# *City of Albuquerque*

REF: 00114 00000 00715 / 00110 00000 00716 / 00128 00000 00718  
(Council Bill No. 0-65, Enactment No. 51-2000)

ANNEXATION, 00114 00000 00715 / 00110 00000 000716, ANNEXING 20 ACRES MORE OR LESS, LOCATED EUBANK BOULEVARD SE, BETWEEN GIBSON BOULEVARD AND KIRTLAND AIR FORCE BASE AND AMENDING THE ZONE MAP TO ESTABLISH IP ZONING.

**SUBJECT:** AX-00114-00000-00715 / 00110-00000-00716 / 00128-00000-00718 The Environmental Planning Commission recommends approval of annexation and establishment of IP zoning for a tract of land in Section 33 T10N, R4E, in the North ½ of the SW ¼ of the NW ¼, located on Eubank Boulevard SE, south of Gibson Boulevard, containing approximately 20 acres. (M-21) Russell Brito, Staff Planner.

**SUBJECT:** NM Commissioner of Public Lands - Approximate 20 Acre Tract Located Near the Former City of Albuquerque Eubank Landfill - Project # 1000554.

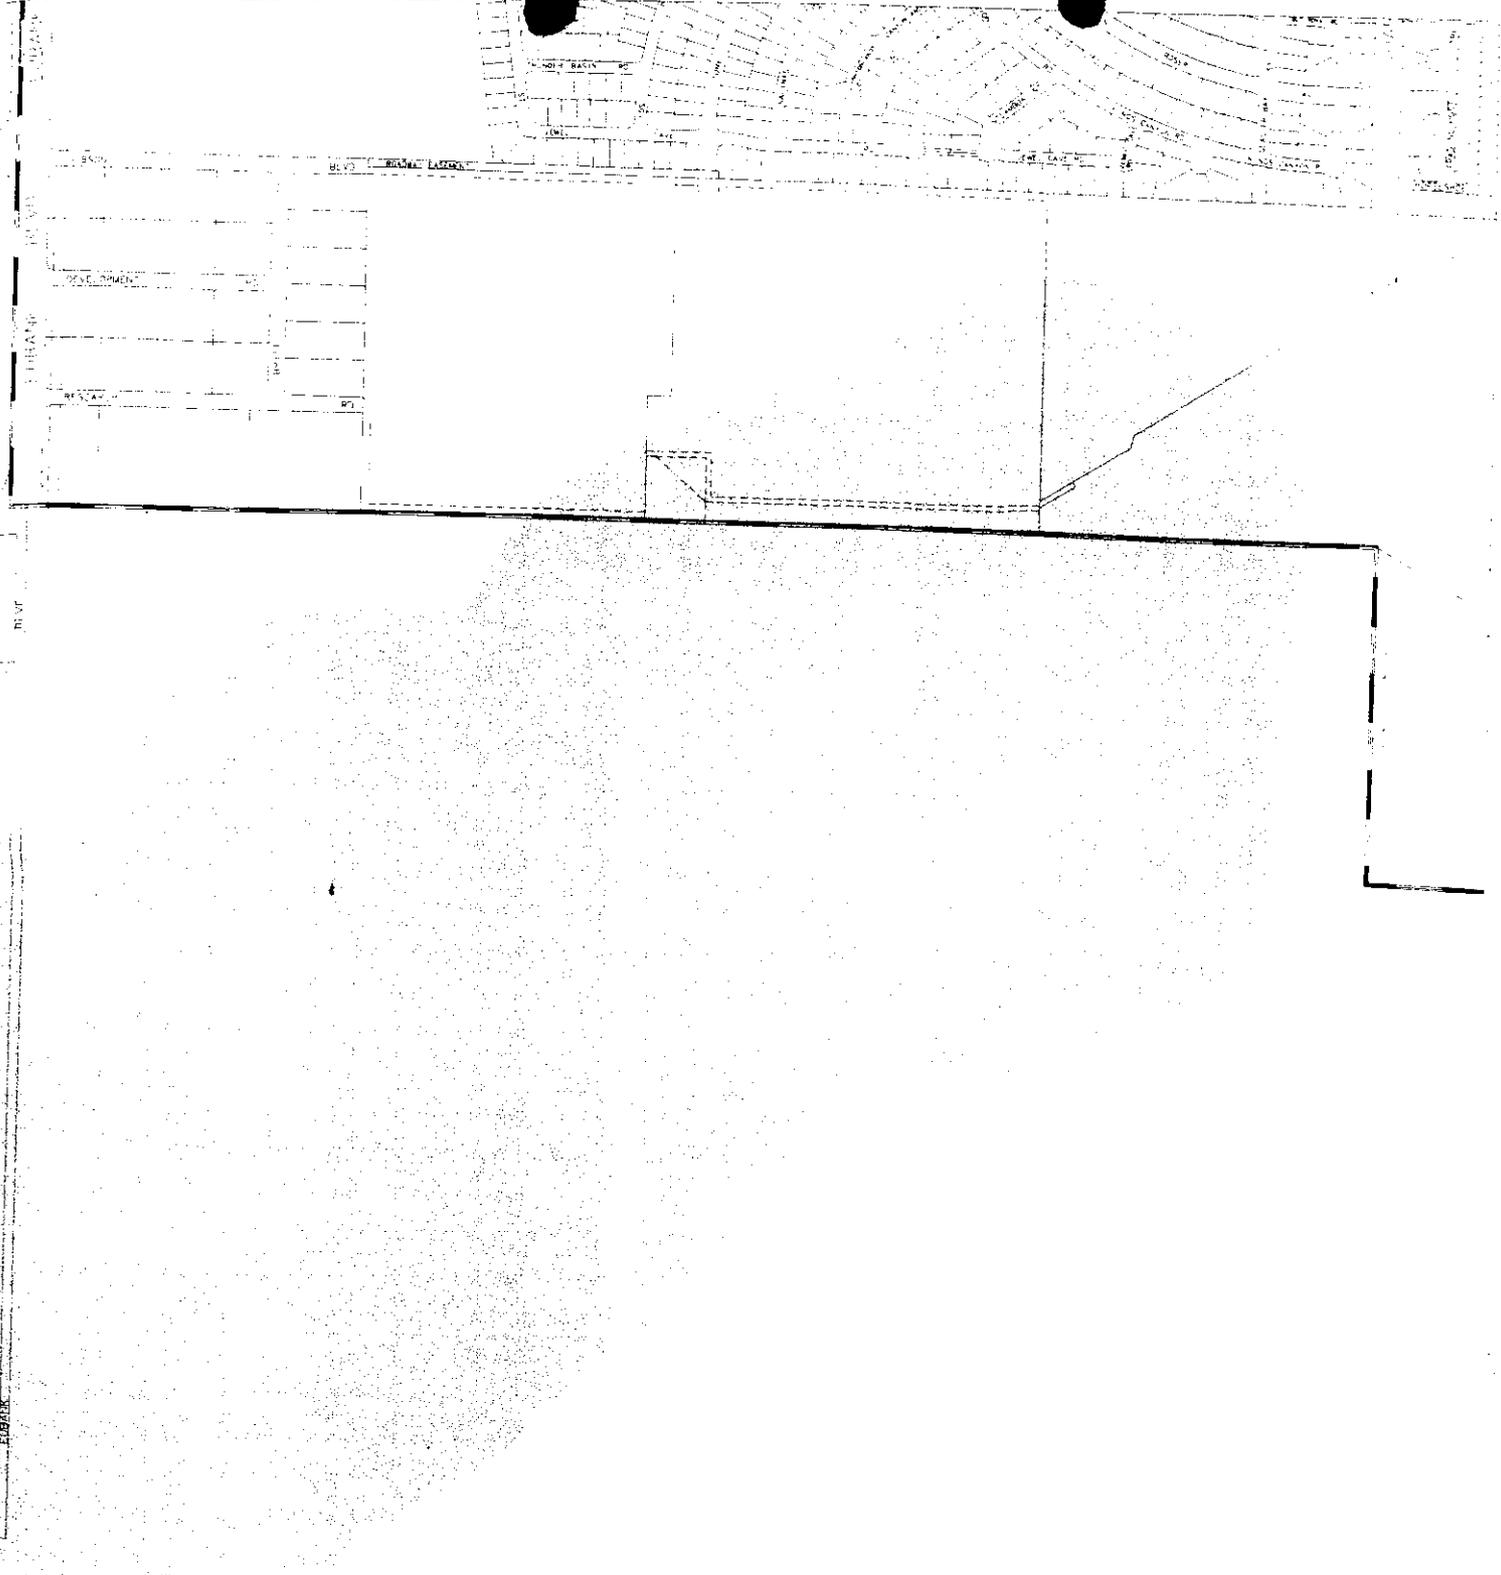
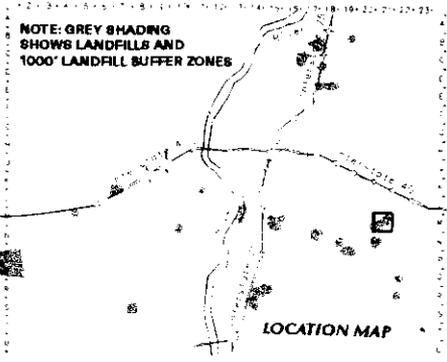
This approximate 20 acre tract is located within the 1000 foot radius of the former Eubank Landfill. Because of the proximity to a former landfill, there is a concern that landfill gas may be present on or near the site. Due to this condition, it is required by AFHD that any development proposed for this tract answer the following question concerning this property.

Has the site been screened for the presence of landfill gas or are there plans to perform such a screen? Landfill gas generated from former landfills can become a health and safety issue for workers or occupants. For this reason Albuquerque Environmental Health Department suggests the following in regard to any future development at the site.
